CLEVE HILL SOLAR PARK

UPDATES TO EXISTING DOCUMENTS OUTLINE CONSTRUCTION TRAFFIC MANAGEMENT PLAN (TRACKED)

August 2019
Revision C

Document Reference: 6.4.14.1
Submitted: Deadline 4

Appendix D – Route Assessment Drawings

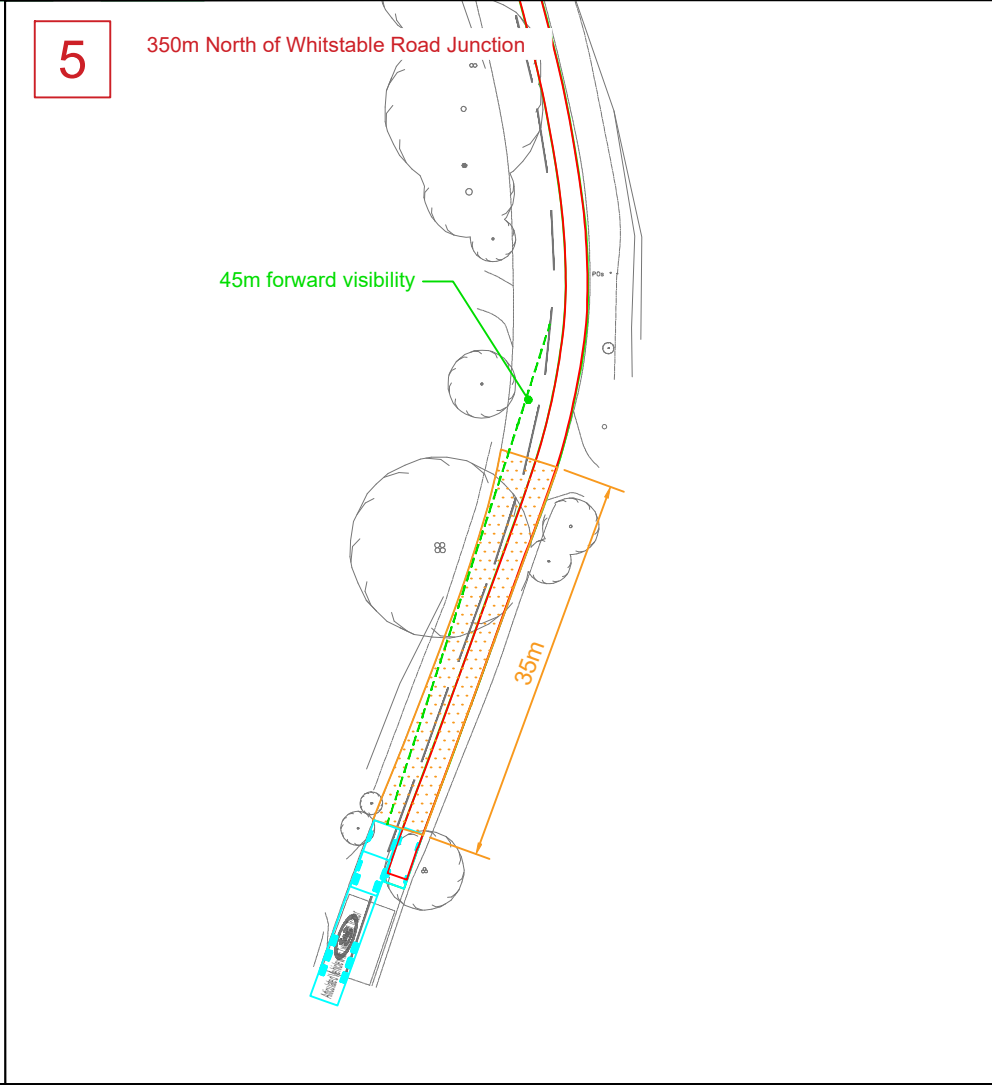
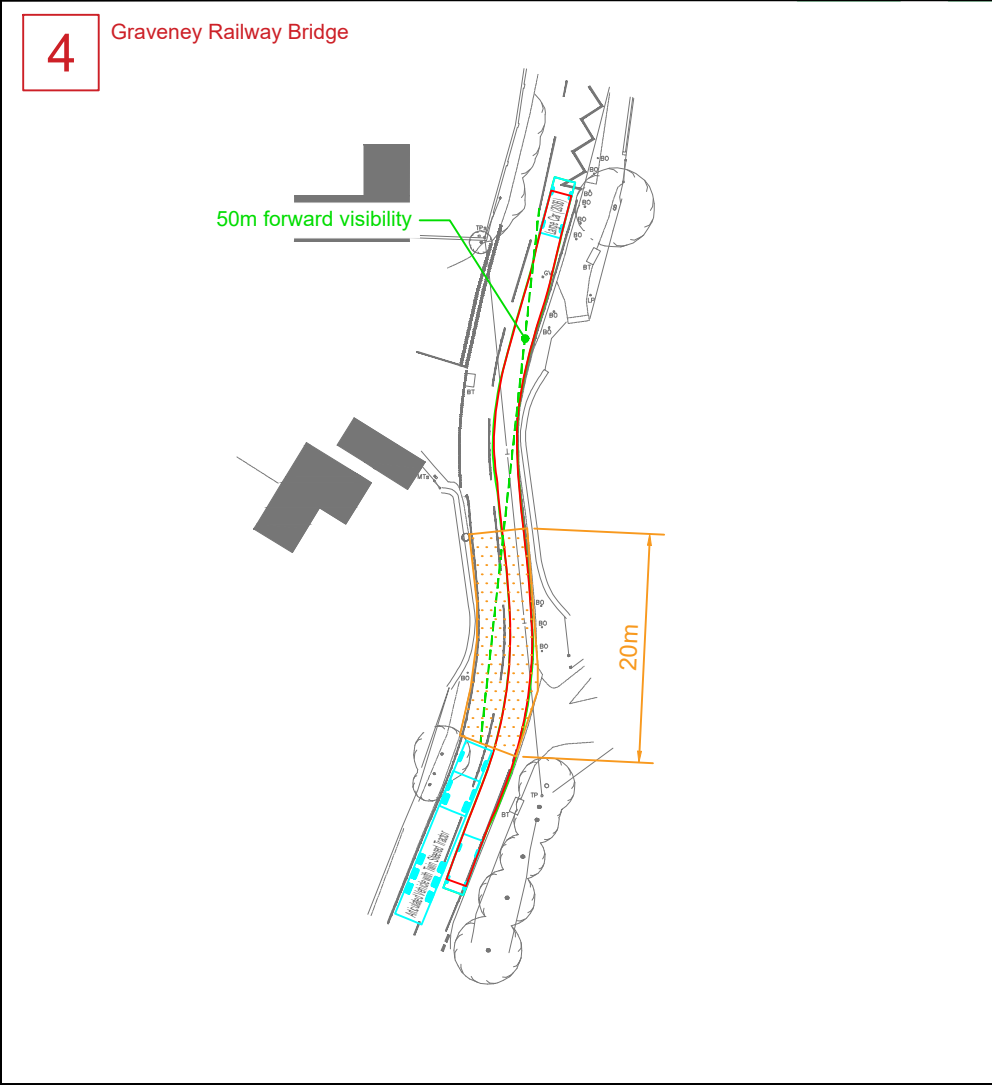
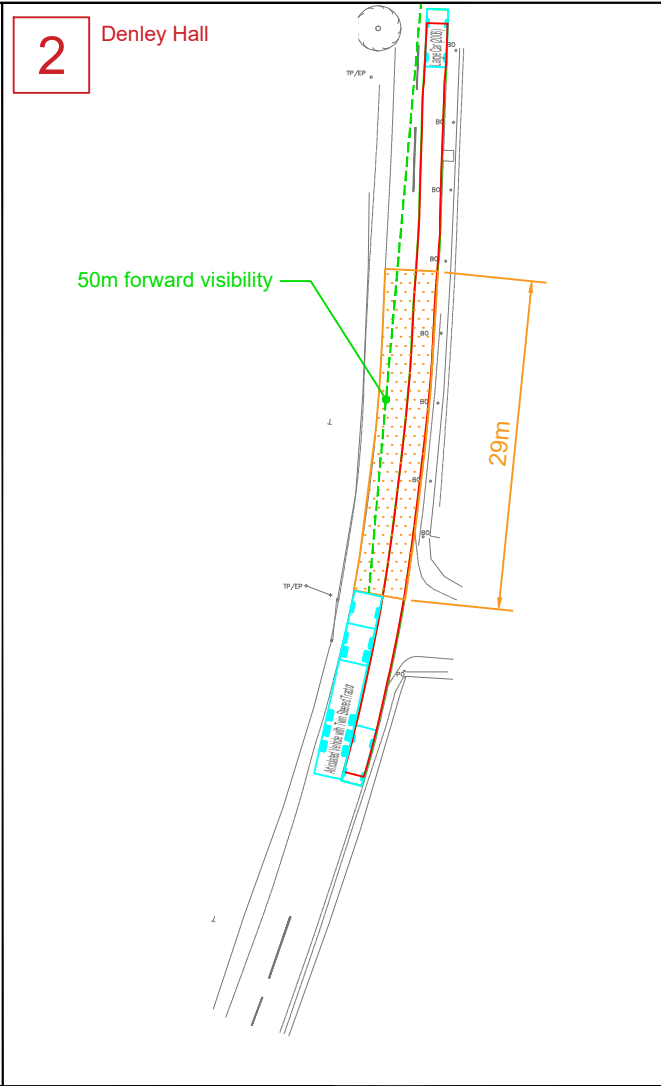
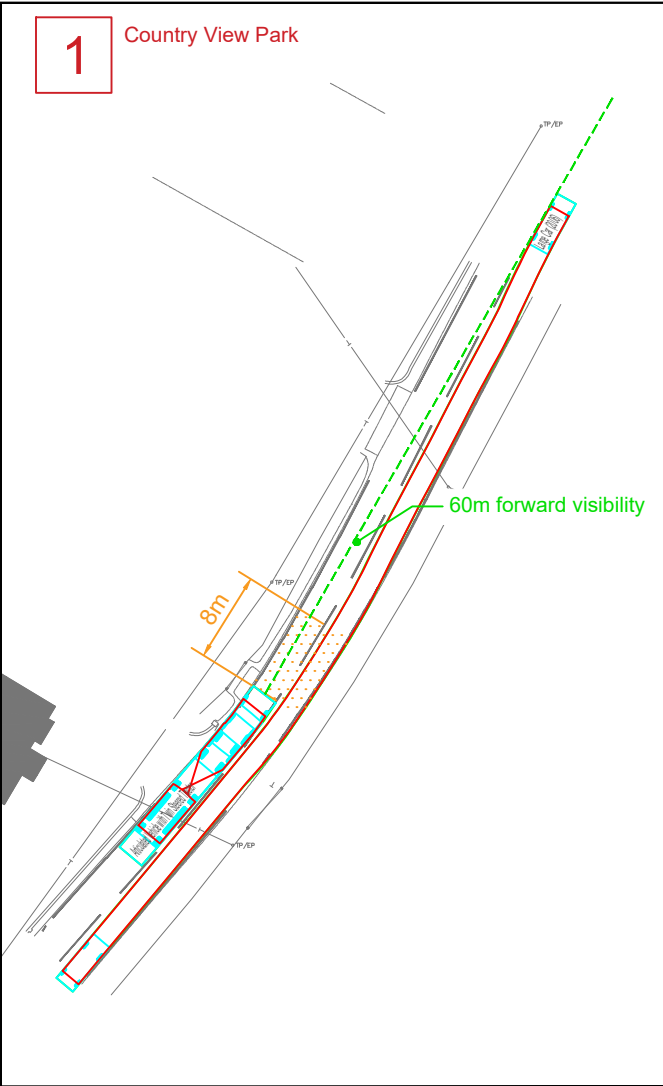
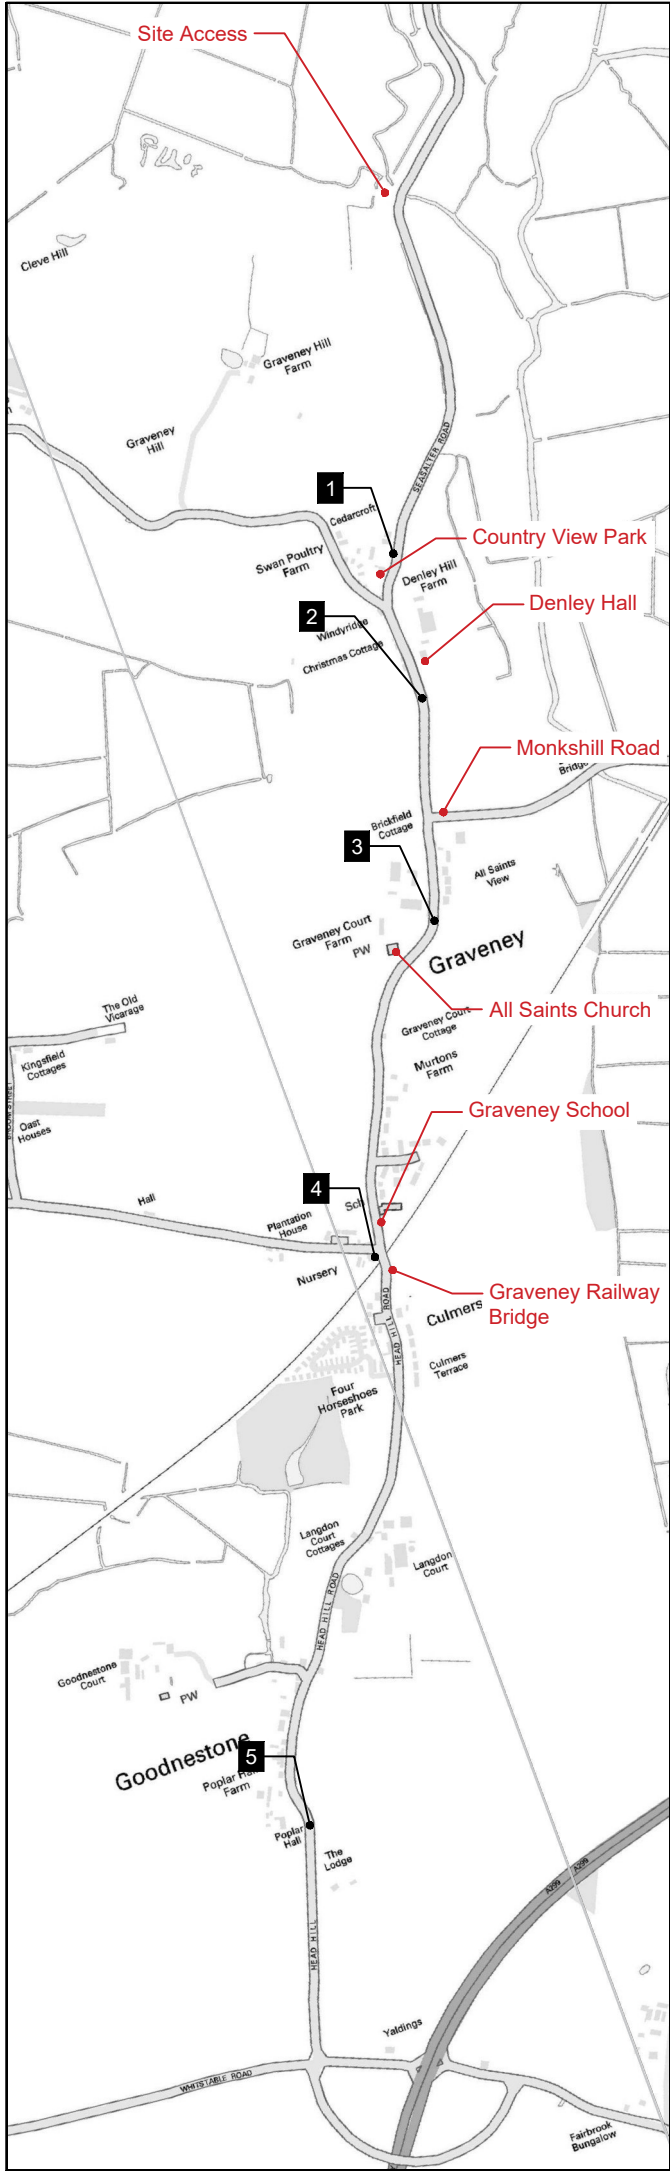
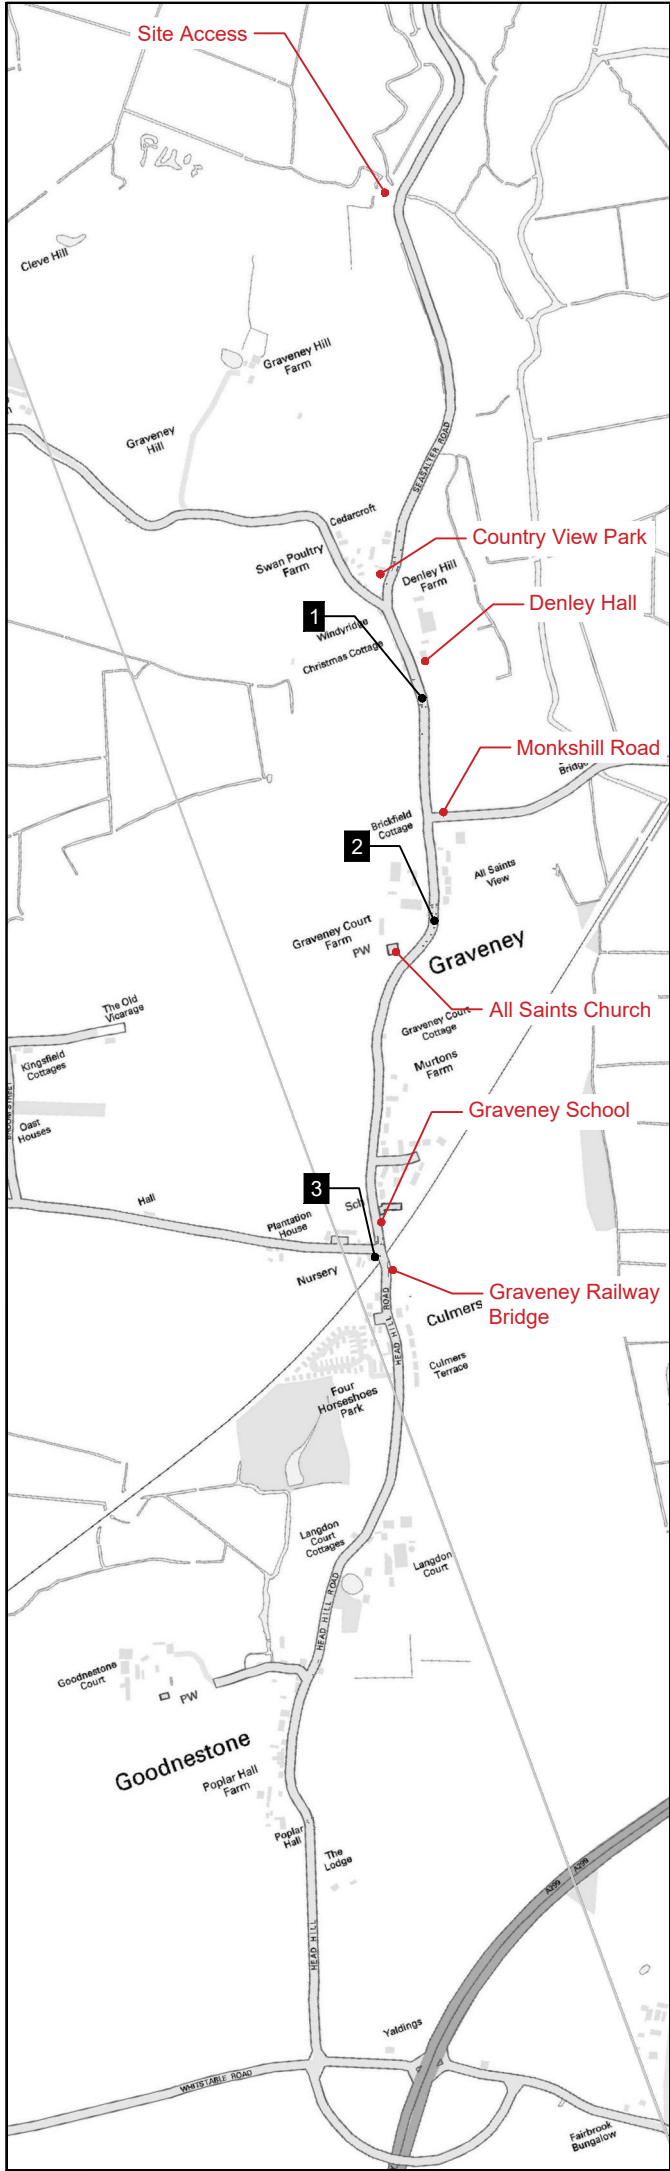
4.2.5 In order to ensure the assessment was accurate, KCC Highways requested that topographical surveys were undertaken at these locations. In addition, two further locations were requested to be surveyed, these include:

4.2.6 Swept path analysis has been undertaken using the topographical surveys and this has demonstrated that the additional area north of St Bartholomew's Church access road can accommodate a car and a large HGV simultaneously. The location 350 north of the Whitstable Road junction can accommodate a large car when a large rigid vehicle is travelling southbound, however there is section of road where this is not possible travelling northbound.

4.2.7 Drawings SK008 and 009 illustrate swept path analysis where vehicles cannot pass simultaneously. However, there is sufficient forward visibility to allow HGV drivers to give way to oncoming traffic.

~~4.2.2 In total four locations have been identified whereby a large HGV and a large car may experience difficulty in passing each other. These are shown on Drawing 0003 and 004 contained within **Appendix D** and include:~~

4.2.8 The topographical surveys do not fundamentally change the conclusions found during the initial swept path assessment.

4.2.9 Measures will be taken to minimise the potential for two CHSP construction HGVs to meet in opposite directions along Head Hill Road and Seasalter Road. This is discussed in further detail in Section 6.7 of the CTMP.
